SERVICE BULLETIN

APPLICABILITY: 2015-2017MY WRX
2014-2017MY Forester Turbo

NUMBER: 09-65-16

SUBJECT: Fuel Injector Design Change to Prevent
Water Intrusion

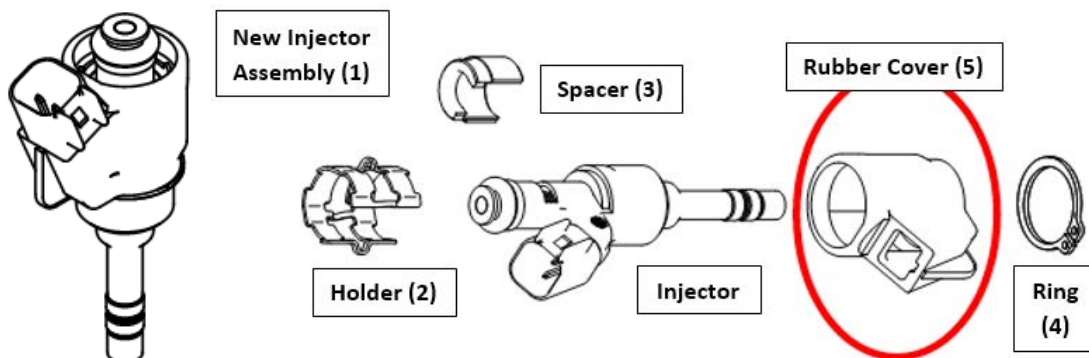
This bulletin announces a design change of the fuel injector used on 2.0L DIT models to prevent water intrusion. A new silicone rubber cover has been developed and incorporated into production for this purpose.

The new injectors were incorporated into production per the table below:

Vehicle / Model	Starting VIN
WRX	H*811518
Forester	H*427213

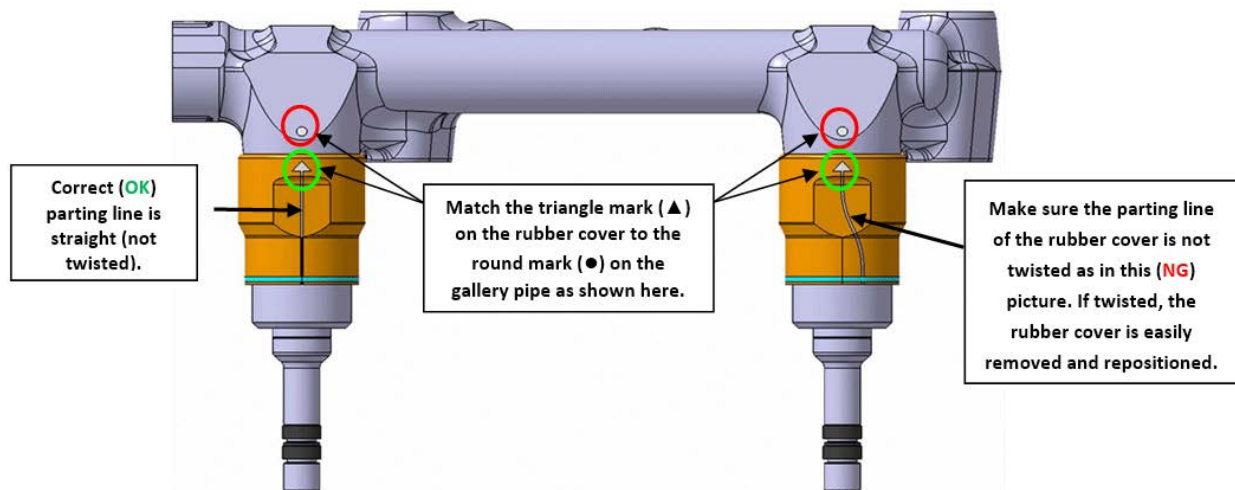
NOTE: The parts table below for new-style injectors is provided for reference only. The silicone rubber cover (5), ring (4) and spacer (3) are not intended for retrofit to old injectors.

***NOTE:** The use of these parts is restricted.

- These parts may ONLY be used to repair p.n. 16600AA030 injectors that came equipped with the silicone rubber covers. As an example, the covers should be replaced if they become swollen or distorted due to exposure to an incompatible fluid (e.g. brake fluid).
- They must NEVER be used in an attempt to retrofit older injectors which did not come equipped with these covers originally.
